**TECHNICAL EVALUATION REPORT  
MONTICELLO NUCLEAR GENERATING PLANT  
STATION BLACKOUT EVALUATION**

TAC No. 6B569

April 19, 1991

**U.S. Nuclear Regulatory Commission  
Washington, D.C. 20555**

Figure 1. Monticeilo Offsite /Onsite Electrical Connections

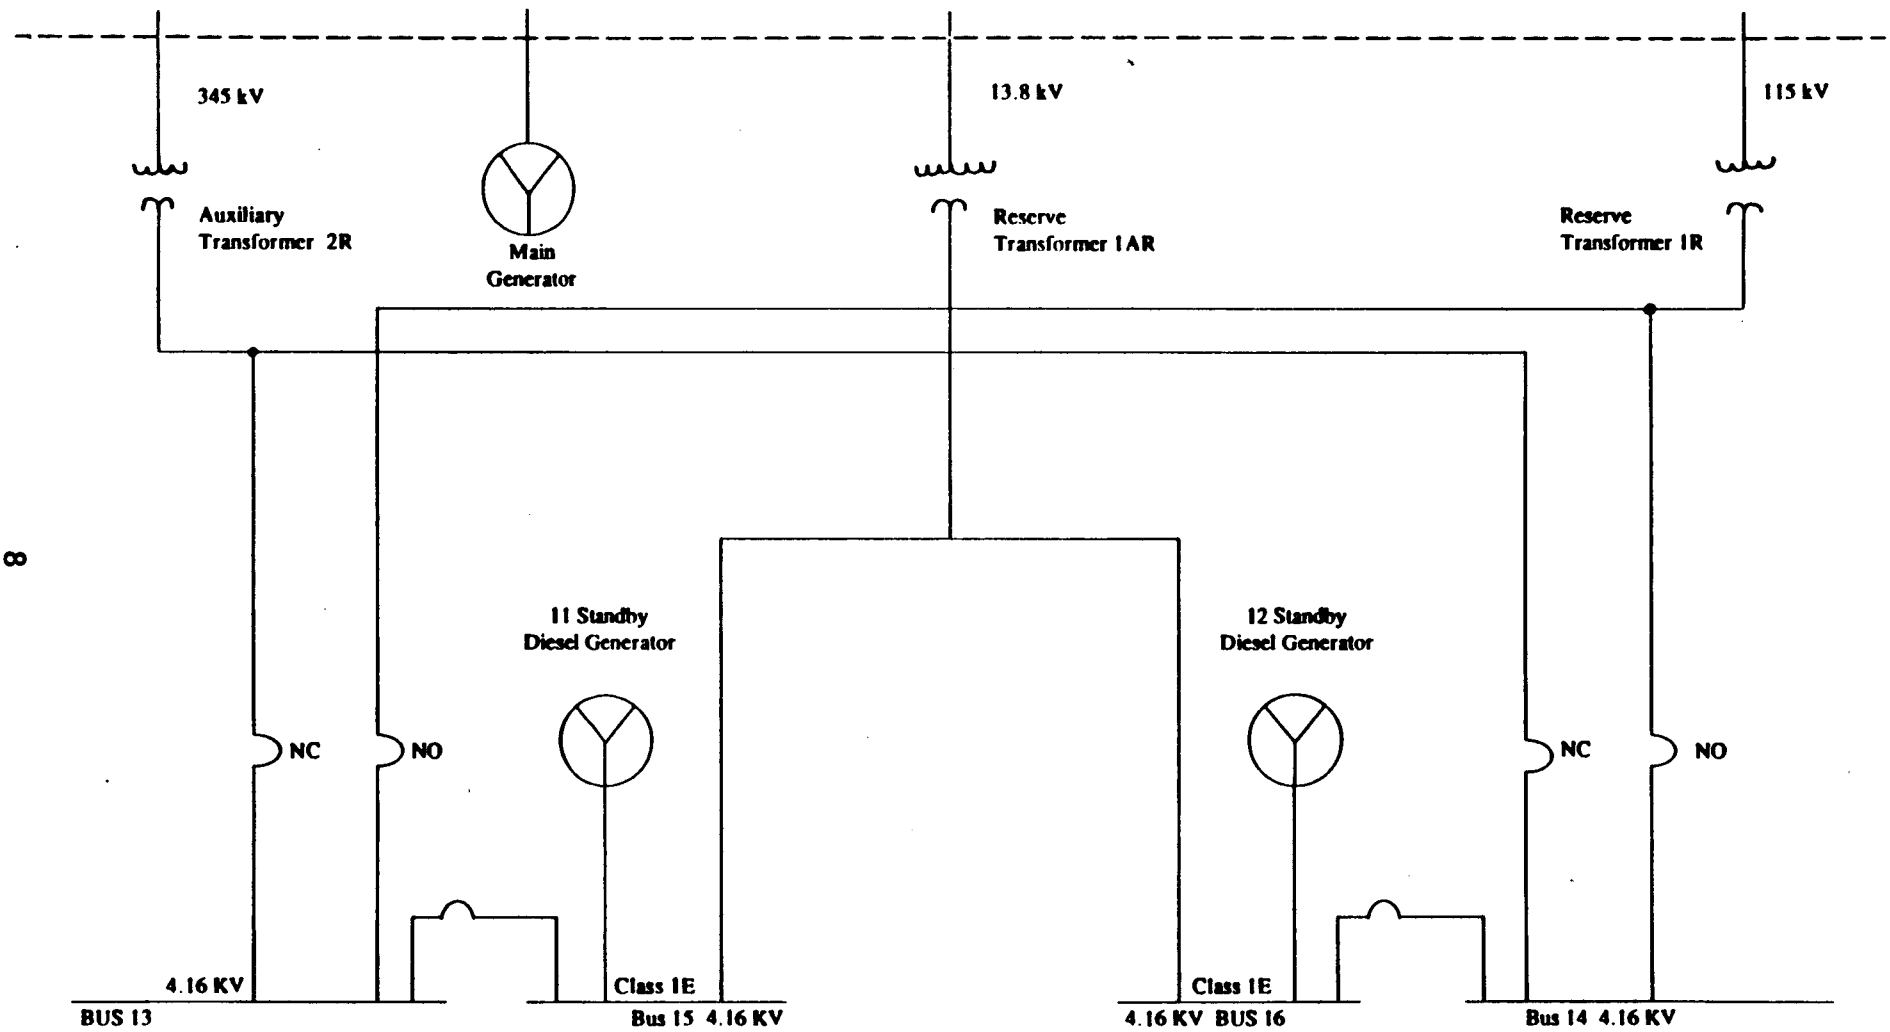
Our review of the plant USAR indicates that safeguards equipment has three offsite supplies of electrical power, the No. 1 reserve transformer (1R), the primary station auxiliary transformer (2R) and the auxiliary reserve transformer (1AR) (Figure 1). Each power source can be connected to both safeguards buses. In addition:

1. All offsite power sources are connected to the plant through electrically connected switchyards,
2. The safeguard buses are normally powered from offsite power sources through primary Station Auxiliary Transformer 2R, and
3. Upon a loss of power for this transformer, the safeguard buses are powered by No. 1 reserve transformer through an automatic transfer.

Based on this, the Monticello offsite power characteristics is classified as "I2," per guidance provided in RG 1.I55, Table 5.
